REMARKS

This amendment is submitted in response to the Official Action Dated November 11, 2003. Claims 1-14 were pending in the Application. Claims 1-14 stand rejected. Also the drawings were objected to.

In Re: Application of: Winter, T.
Deep-Ribbed, Load-Bearing, Prefabricated
Insulative Panel and Method for Joining

Fig. 1

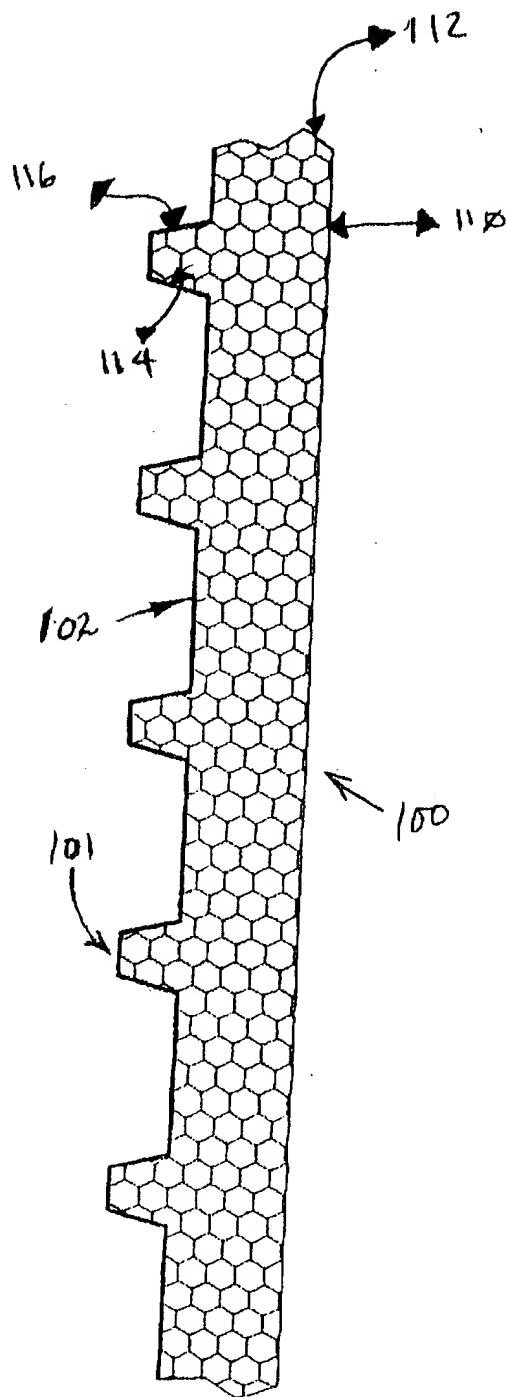
The drawings have been amended to overcome the rejections. With respect to the objections to Figures 1 and 1A, a replacement drawing sheet 1/5 is included herewith, to remove the text from Figure 1 and to darken some of the component numbers to make them more easy to read. Therefore, Applicant respectfully requests withdrawal of this objection and acceptance of the replacement drawing sheet. No new matter has been added.
